Amendments to the Drawings:

The attached replacement sheets of drawings includes changes to Figs. 1, 3 and 7 and replaces the original sheet including Figs. 1, 3 and 7.

Claims 1-17 are pending. Claims 1, 7 and 12 are independent.

1
G
F

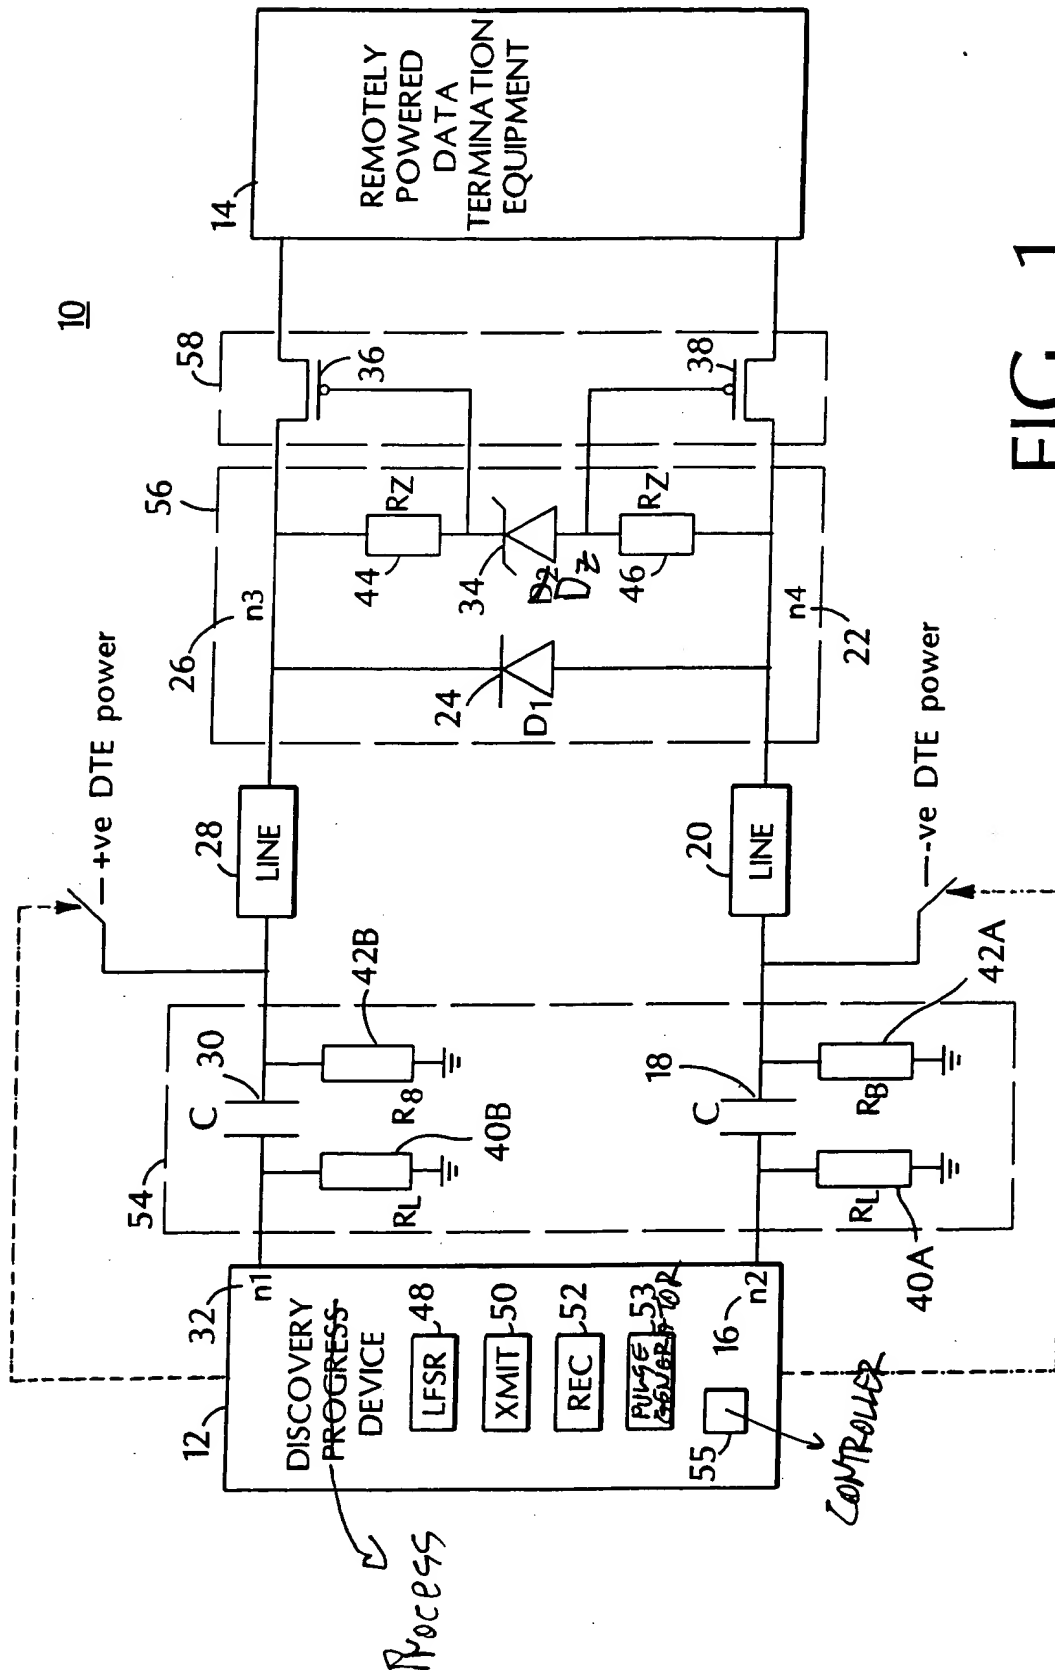
In Figure 1, applicant replaced the reference "D₂" with "D_z", replaced the word "PROGRESS" appearing in item 12 with "PROCESS", and added a the descriptors "PULSE GENERATORS" and "CONTROLLER" to items 53 and 55, respectively, within item 12 .

FIG. 3

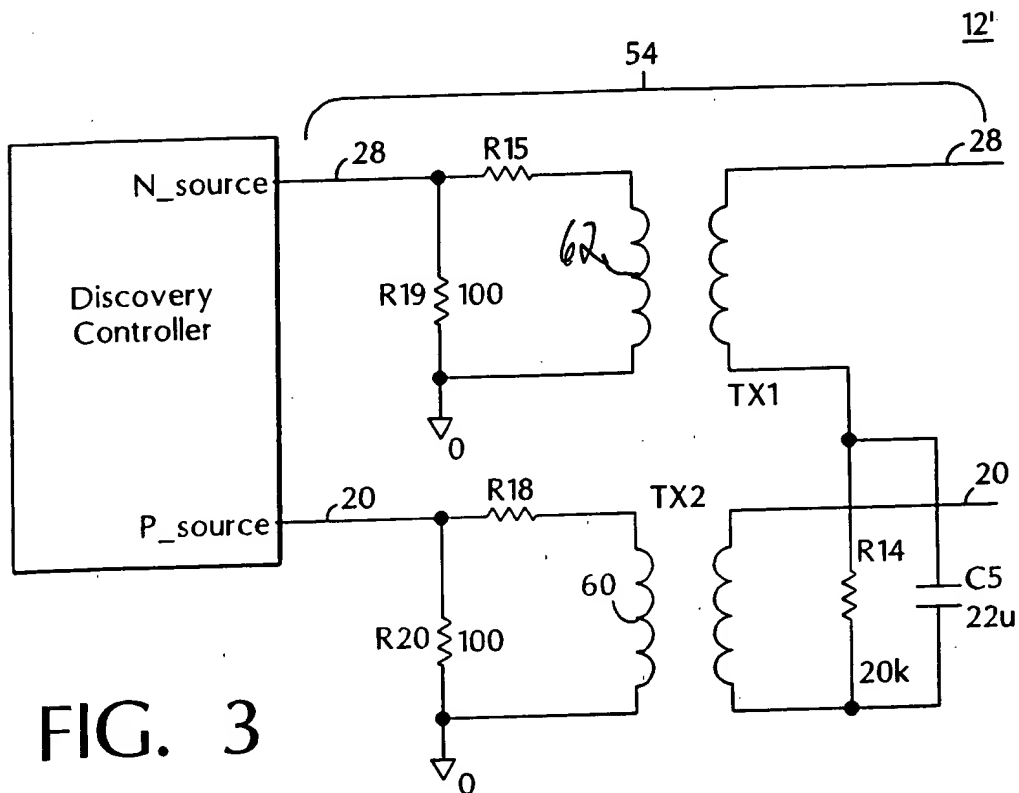
In Figure 3, applicant added the reference numeral 62 to the transformer coupled to receiver line 28.

FIG. 7

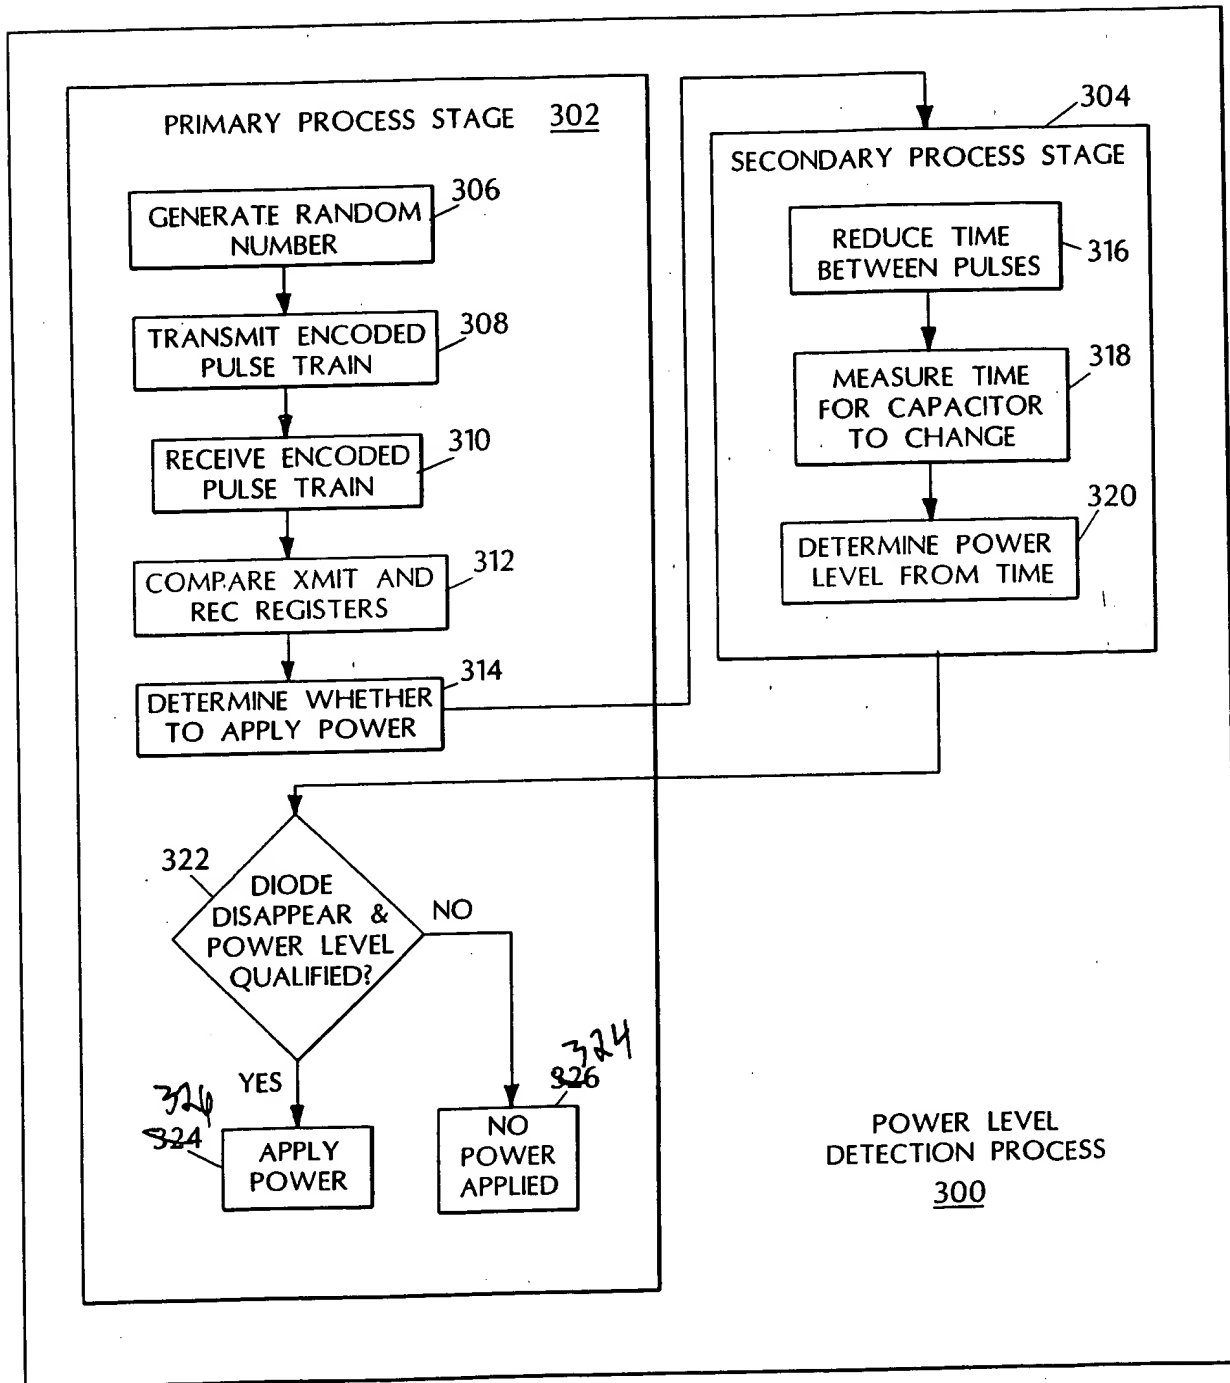
In Figure 7, applicant amended the drawing to switch reference numerals 324 and 326 so that the corresponding items are marked in a manner consistent with the Description of the above-identified application.
